Resolution PC 24 32 DR 09

CITY OF
FLORENCE

Design Review: Convenience Store, Fuel station, and attached coffee shop with drive-thru.

Proposed Stormwater

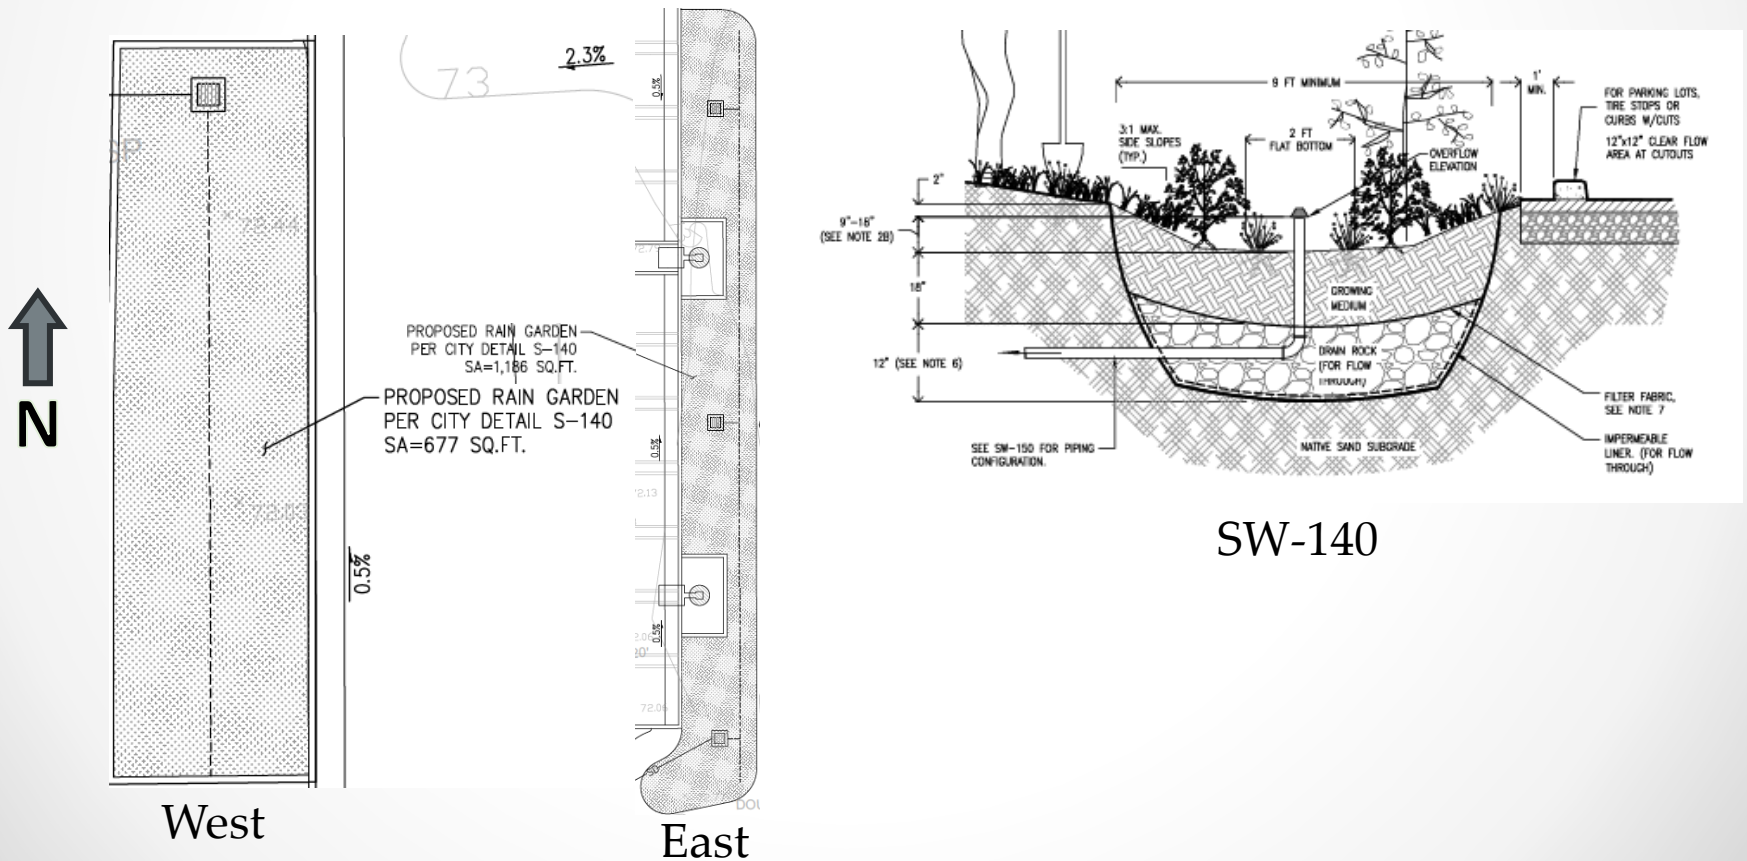
- Two rain gardens proposed.
- City of Florence Rain garden typical proposed to be used.

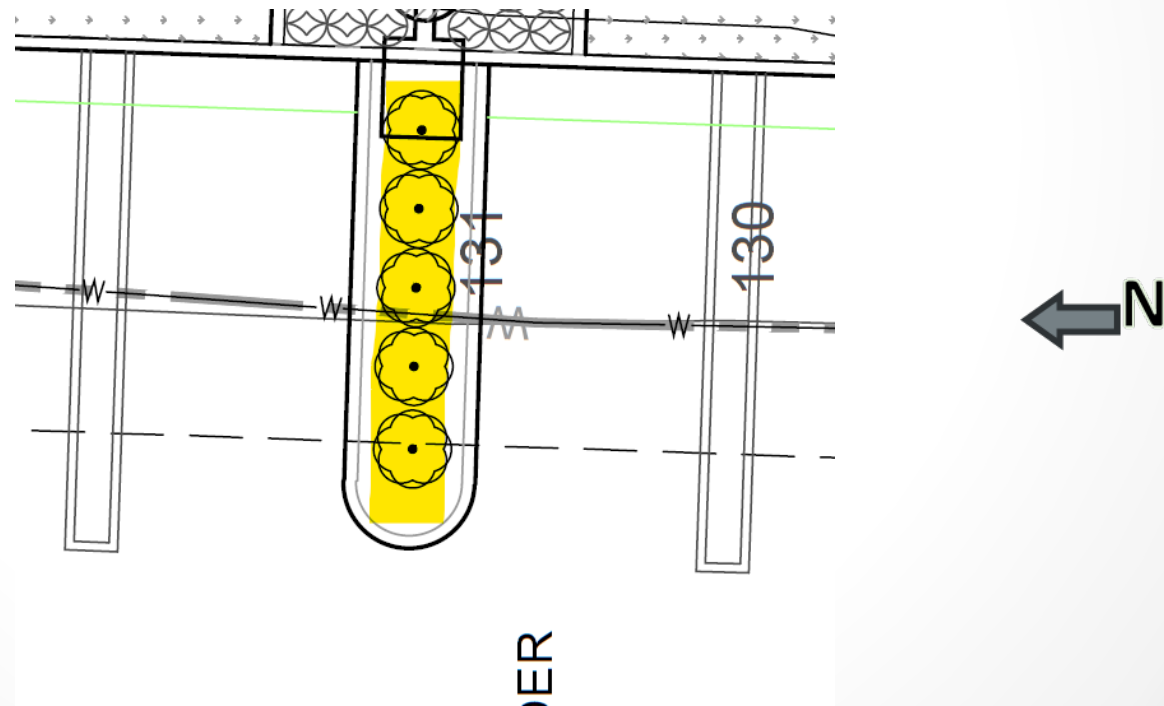
10. A tree shall be added to the parking island along the east property line, and shall be selected from the tree and plant list for the City of Florence.

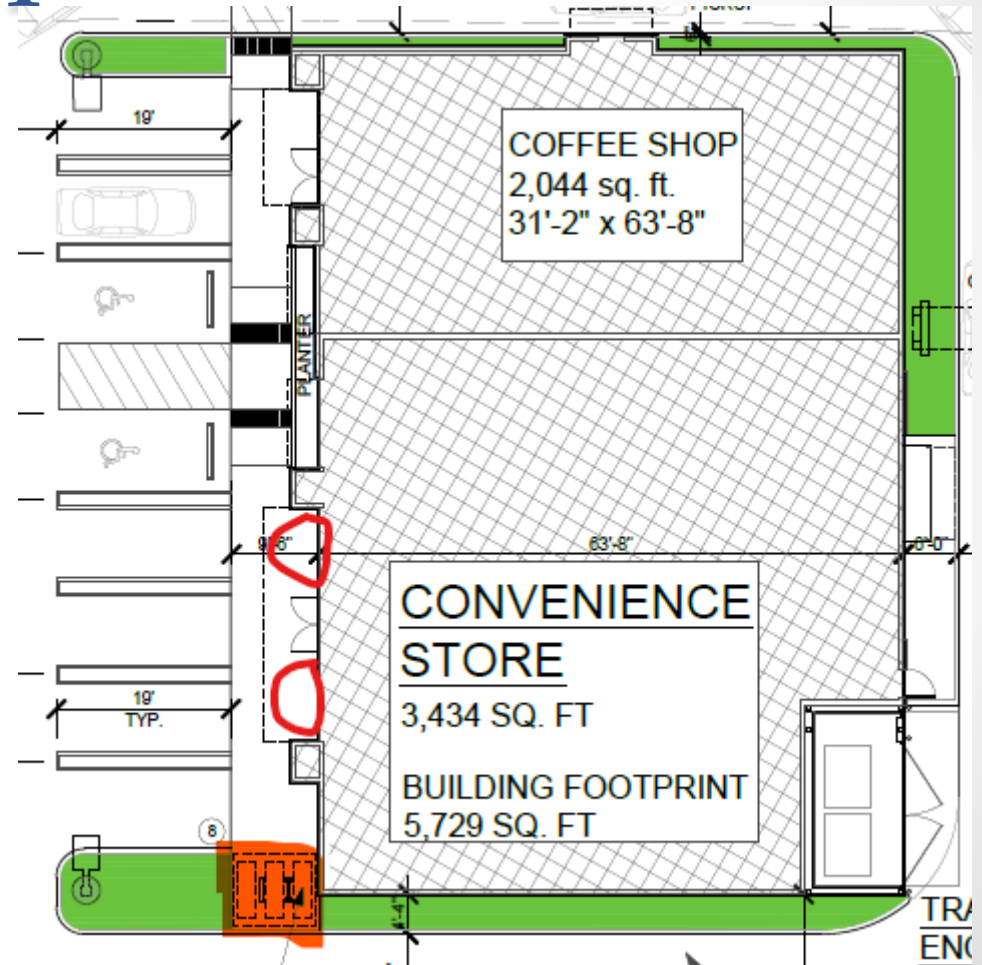
11. Landscape plantings shall be 3-4 feet in height for screening on HWY 101 and be maintained so as not to interfere with pedestrian and bicycle access in accordance with FCC 10-35-2-13.

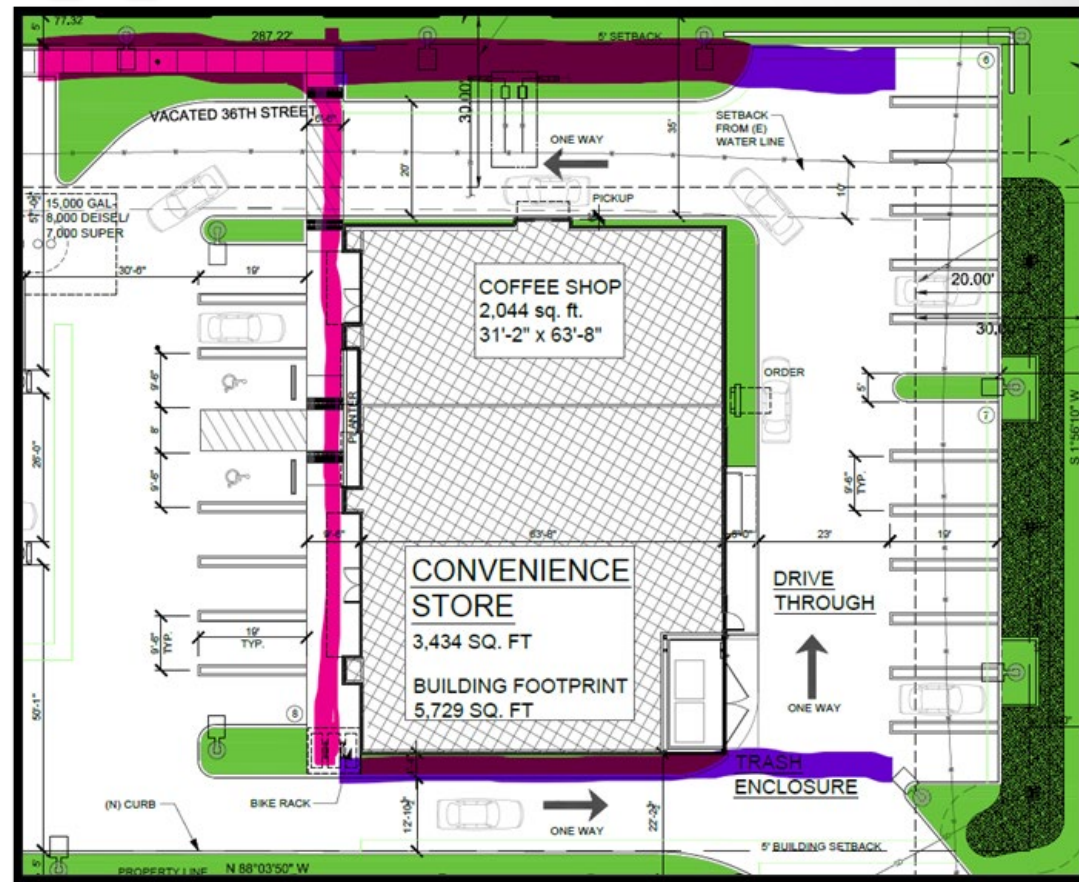
17. The walkway from Highway 101 shall be extended along the north property line to the east parking area with associated crosswalks.

18. A walkway shall be installed along the southern portion of the building to connect to the east parking area with associated crosswalks.

19. Pedestrian crosswalks shall be marked with contrasting paving materials, such as light-colored concrete between the asphalt.

20. All pedestrian walkways shall be five feet wide, not including the curb width.
